MIAMI-DADE COUNTY

COMMUNITY ZONING APPEALS BOARD 2

MIAMI-DADE COUNTY DEPARTMENT OF PLANNING AND ZONING
RECOMMENDATION TO COMMUNITY COUNCIL No. 2

APPLICANT: Lenin Antonio Ferrera **PH:** Z08-58 (08-12-CZAB2-1)

SITE PLAN
SCALE:1/16"=1'-0"

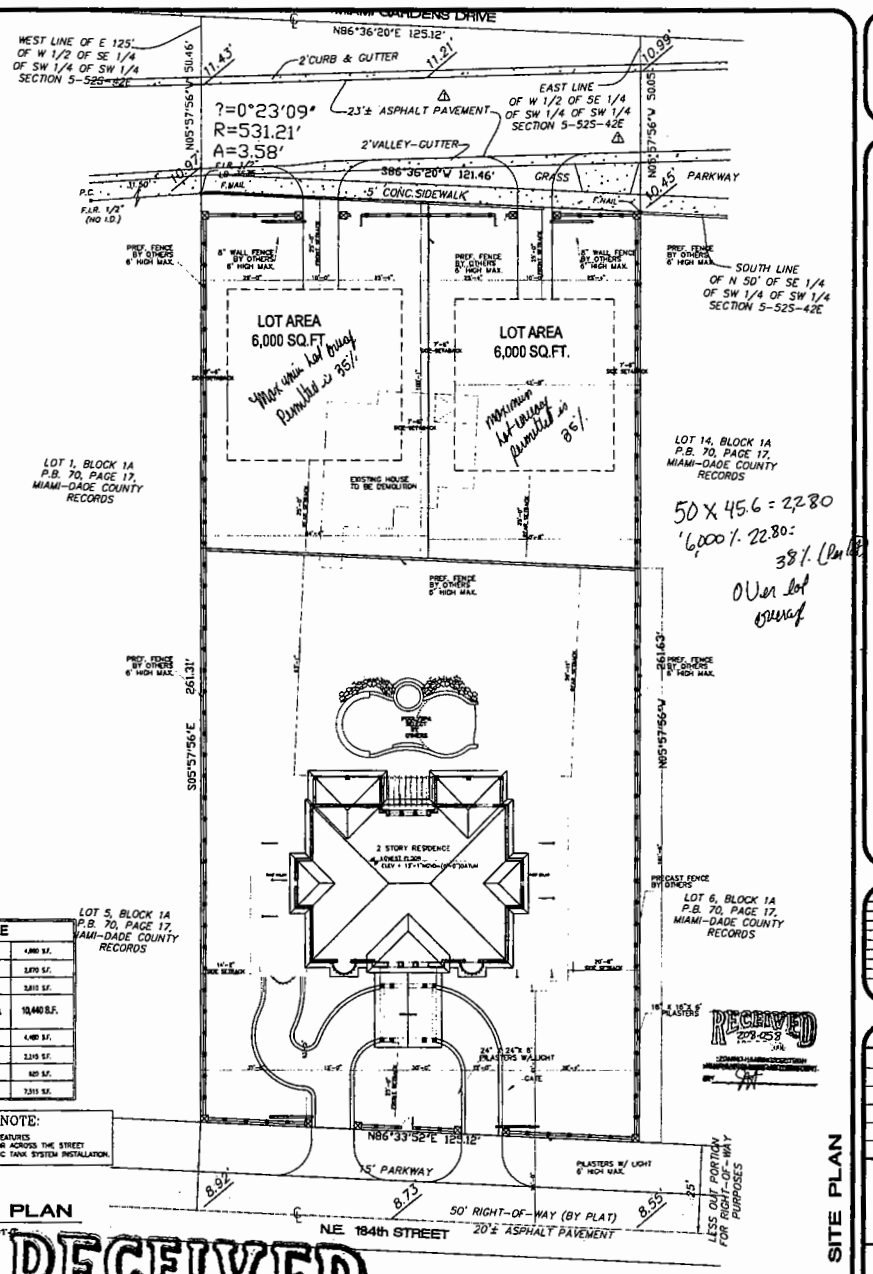
Site Plan Review:	(Plans submitted)
Scale/Utilization of Site:	**Unacceptable**
Location of Buildings:	**N/A**
Compatibility:	**Unacceptable**
Landscape Treatment:	**N/A**
Open Space:	**N/A**
Buffering:	**N/A**
Access:	**Unacceptable**
Parking Layout/Circulation:	**N/A**
Visibility/Visual Screening:	**N/A**
Energy Considerations:	**N/A**
Roof Installations:	**N/A**
Service Areas:	**N/A**
Signage:	**N/A**

The subject 0.95-acre parcel is an interior parcel with dual frontage in the middle of a block developed with single-family residences, which can be found to the east, west and south of the site. Apartments are located to the north of the subject site. The applicant is seeking to rezone the 0.95-acre parcel from GU, Interim District, to RU-1, Single-Family Residential District, (Request #1). Additionally, the applicant is seeking to permit two (2) of the proposed three (3) lots with a lot frontage of 60' and with a lot area of 6,000 sq. ft. each, where the Zoning Code requires 75' of lot frontage and 7,500 sq. ft. of lot area. The applicant has submitted plans depicting the subdivision of the 0.95-acre parcel of land into three proposed lots; one (1) proposed conforming lot to face NE 184 Street with a lot frontage of 125' and a lot area of 20,200 sq. ft. and two (2) proposed substandard lots to face Miami Gardens Drive. Each substandard lot has a lot frontage of 60' where 75' of lot

frontage is required and a with a lot area of 6,000 sq. ft. where 7,500 sq. ft. of lot area is required. The subject property contains an existing single family residence which, as depicted by the plans submitted for this application, will be demolished in order to allow a proposed two-story single family residence on the conforming lot to front on NE 184 Street and two proposed residences on the two proposed substandard lots facing Miami Gardens Drive. However, the applicant has not submitted plans for the proposed single-family residences on the two proposed substandard lots facing Miami Gardens Drive.

When Request #2 is analyzed under the Non-Use Variance (NUV) Standard, Section 33-311(A)(4)(b), staff is of the opinion that the approval of the request would affect the stability and appearance of the community and would be **incompatible** with the surrounding area. The approval of the request, to permit two (2) of the proposed three (3) lots with lot frontages of 60' where 75' is required and a lot area of 6,000 sq. ft. where 7,500 sq. ft. is required will result in an obvious departure from the aesthetic character of the surrounding area. Staff notes that the subject property is located in the middle of a block which is developed with single family residences to the east, west and south on sites ranging from approximately 7500 sq. ft. to over 9,000 sq. ft. in lot area, and with minimum lot frontages of 75'. Staff also notes that there have been no similar approvals in the area. As such, staff is of the opinion that the proposed two (2) substandard lots would be **incompatible** with the existing single-family residences lying to the east and west on the same block where the subject property is located and would be an obvious departure from the aesthetic character of the existing homes on the same block that face onto Miami Gardens Drive and with the existing homes lying to the south of the subject property. Notwithstanding staff's recommendation for denial of Request #2, as previously indicated, if Request #1 is approved, the applicant has the option to purchase two Severable Use Rights which would allow the subdivision of the 0.95-acre dual frontage parcel into four lots with 6,000 sq. ft. of area and 60' of frontage. As such, staff recommends denial without prejudice of Request #2 under Section 33-311(A)(4)(b) (NUV).

that the development requested is in compliance with the applicable ASDO Standards and does not contravene the enumerated public interest standards as established. This application meets some of the criteria for approval under the ASDO Standards for lot frontage and area. Specifically, the site provides sufficient frontage for vehicular access (Section 33-311(A)(14)(d)(1)(G)); the size is sufficient to provide all setbacks (Section 33-311(A)(14)(d)(1)(C)); the site is not zoned GU or AU; and the site is not designated as agriculture or open land on the LUP map of the CDMP (Section 33-311(A)(14)(d)(1)(F). Further, the parcel is under lawful separate ownership from any contiguous property, is not otherwise grandfathered for single family or duplex use (Section 33-311(A)(14)(d)(1)(A)) and will not result in the further subdivision of land (Section 33-311(A)(14)(d)(1)(B)). However, the request, to permit a single-family residence on two substandard lots, each with an area of **6,000** sq. ft. (7,500 sq. ft. required), does not comply with the ASDO Standard in Section 33-311(A)(14)(d)(1)(D) which requires that no lot area shall be less than ninety percent (90%) of the lot area required by the underlying district. Additionally, the substandard sized lots will result in an obvious departure from the aesthetic character of the immediate vicinity as evidenced by the larger sized parcels of land that are prevalent in the surrounding area (Section 33-311(A)(14)(d)(1)(E)). The two (2) proposed substandard lots, each with a lot area of **6,000** sq. ft. fall below the minimum numerical lot area of 6,750 sq. ft., which is the 90% minimum required for approval in this zone under the ASDO Standard. Therefore, the Request #2 cannot be approved under same and should be denied without prejudice under Section 33-311(A)(14) (ASDO).

Approval of Request #1 and denial without prejudice of Request #2 of this application under Section 33-311(A)(4)(b) (NUV), and denial without prejudice of same (Request #2) under Sections 33-311(A)(14) (ASDO), and 33-311(A)(4)(c) (ANUV).
